RS-04-007

Subject: Request for Additional Information Regarding a License Amendment  
Request to Revise the Pressurizer Safety Valves Lift Settings

Attachment 1: Response to a Request for Additional Information (RAI) Regarding a License Amendment Request to Revise the Pressurizer Safety Valves Lift Settings

### Response to a Request for Additional Information (RAI) Regarding a License Amendment Request to Revise the Pressurizer Safety Valves Lift Settings

Figure 1

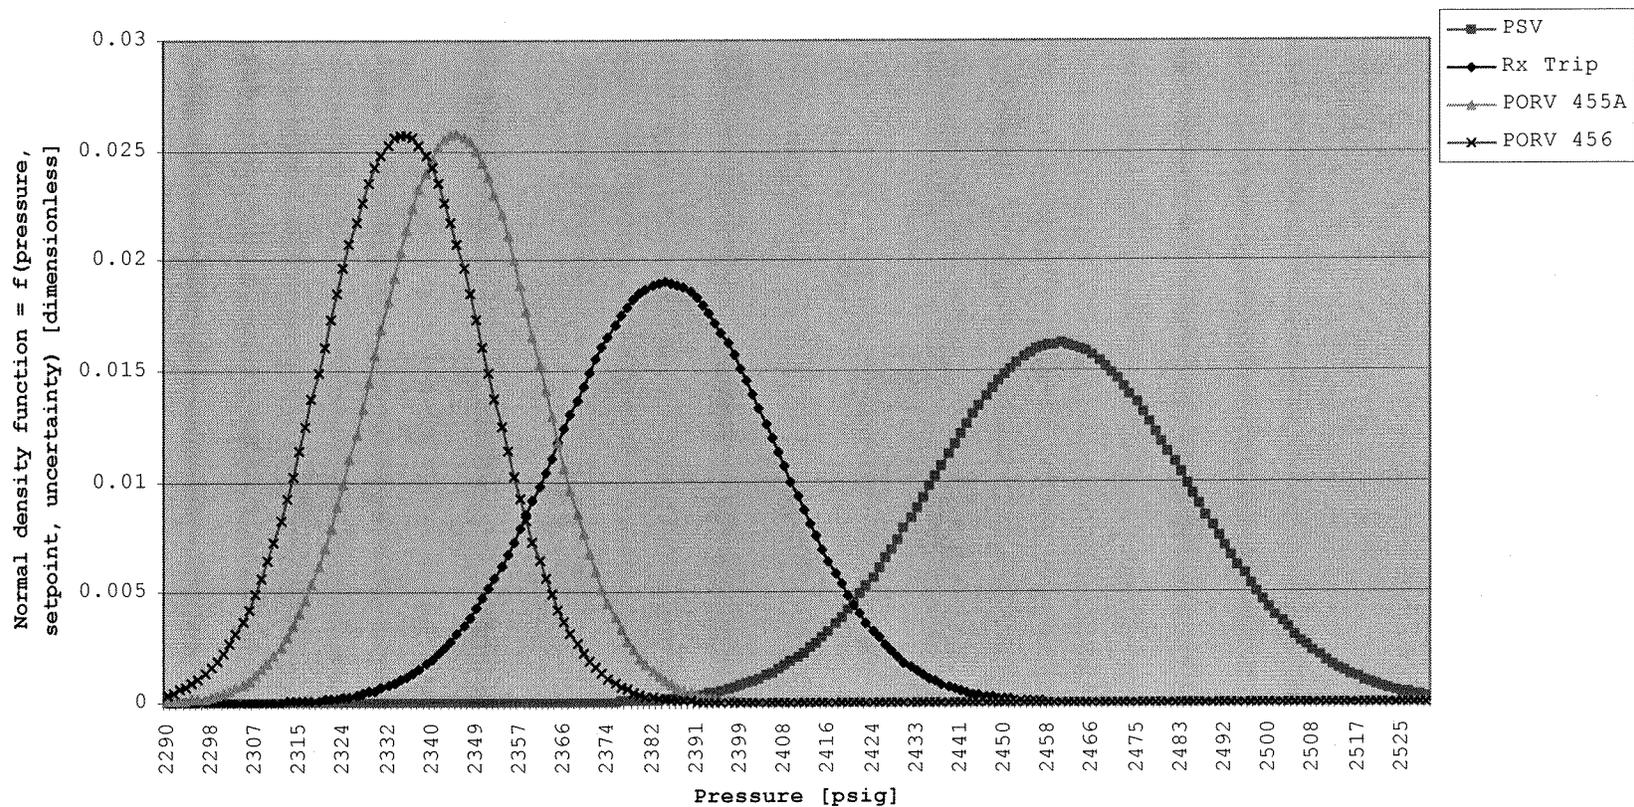
*Specify the pressure measurement uncertainties associated with the high pressure reactor trip and the PSV, and confirm that they are appropriately considered in the error analysis such that a reactor trip will occur prior to PSV actuation.*

Figure 1 illustrates the probabilities associated with the actuation of the setpoints for the pressurizer PORVs, Pressurizer Pressure – High reactor trip, and PSVs. The probability

of having a PSV (i.e., with the new setpoint of 2460 psig) lift before achieving a Pressurizer Pressure – High reactor trip signal (i.e., with a setpoint of 2385 psig, 2 out of 4 logic) is less than 1% for any given pressure. This determination is based on the PSV having an acceptable as found tolerance of  $\pm 2\%$  of nominal setpoint value which equates to  $\pm 49.2$  psig, and the Pressurizer Pressure – High reactor trip uncertainty of  $\pm 5.25\%$  of the 800 psig instrument span (i.e., a span of 1700 psig – 2500 psig) for two channels which equates to  $\pm 42.0$  psig. The uncertainty associated with the Pressurizer Pressure – High reactor trip was calculated using the methodology described in Westinghouse WCAP-12523, "Bases Document for Westinghouse Setpoint Methodology for Protection Systems - Commonwealth Edison Company Zion/Byron/Braidwood Units," dated October 1990. The probability of having a PSV lift before achieving a Pressurizer Pressure – High reactor trip was determined based on the assumption that each function (i.e., PSV actuation and Pressurizer Pressure – High reactor trip) has uncertainties (i.e., errors) that follow a normal distribution and behave according to the fundamental rules of probability. Based on the above, challenges to the safety valves are minimized and the reactor trip is expected to occur prior to the PSV actuation.
